Committee of the Whole Report For the Meeting of May 26, 2022

To: Committee of the Whole **Date:** May 13, 2022
From: Karen Hoese, Director, Sustainable Planning and Community Development
Subject: Development Permit with Variances Application No. 00051 for 937 View Street

That Council decline Development Permit with Variances Application No. 00051 for the property located at 937 View Street.

5 Setback Plan - L12-14
A103 SCALE: 1 : 250

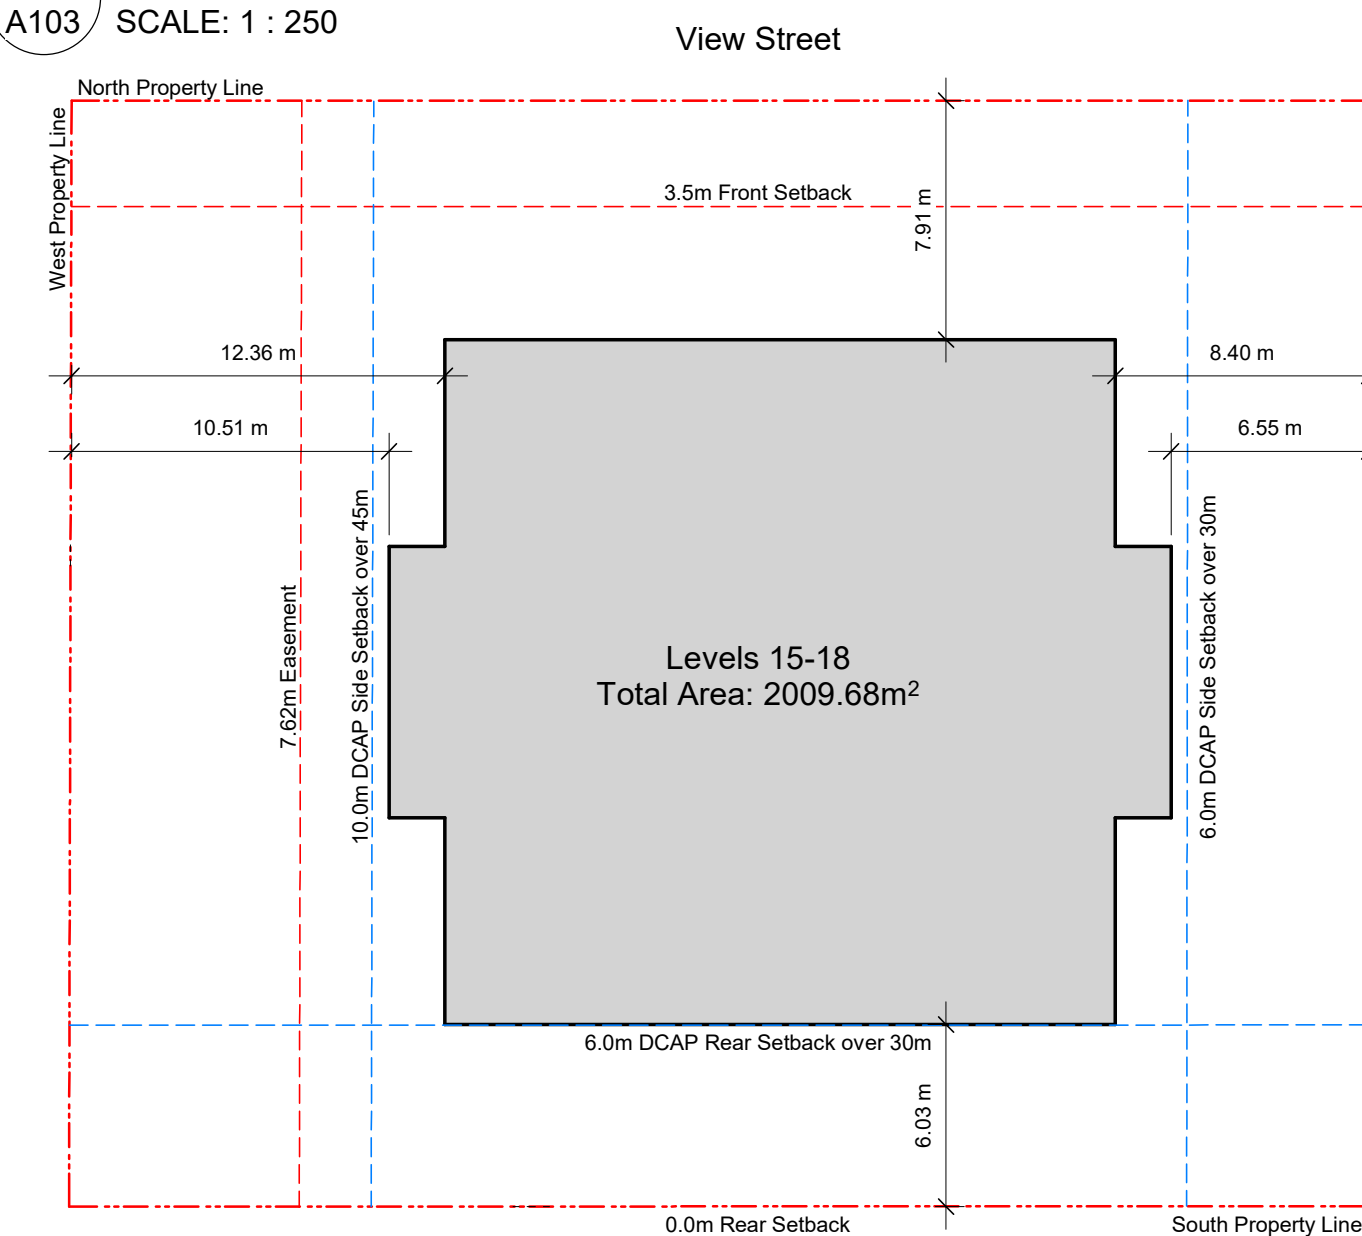
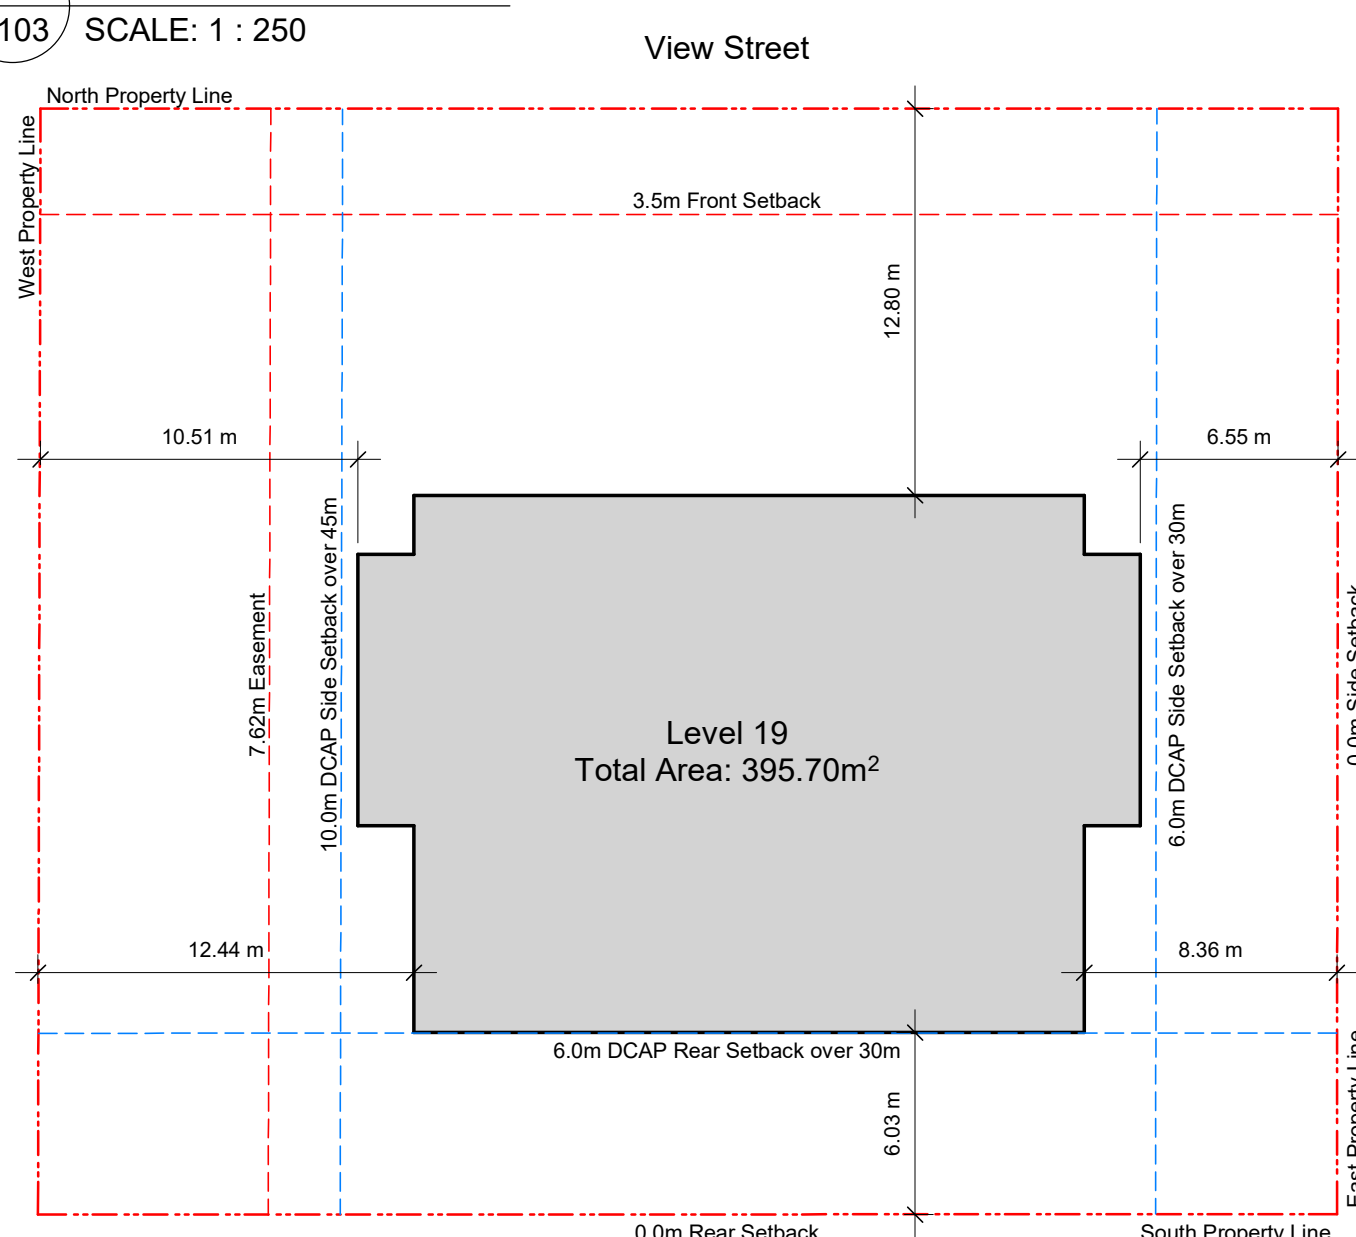
- The upper portions of the tower setbacks on the front (north) do not meet the minimum requirements for street wall heights, with floors 9 to 11 encroaching by approximately 3m.
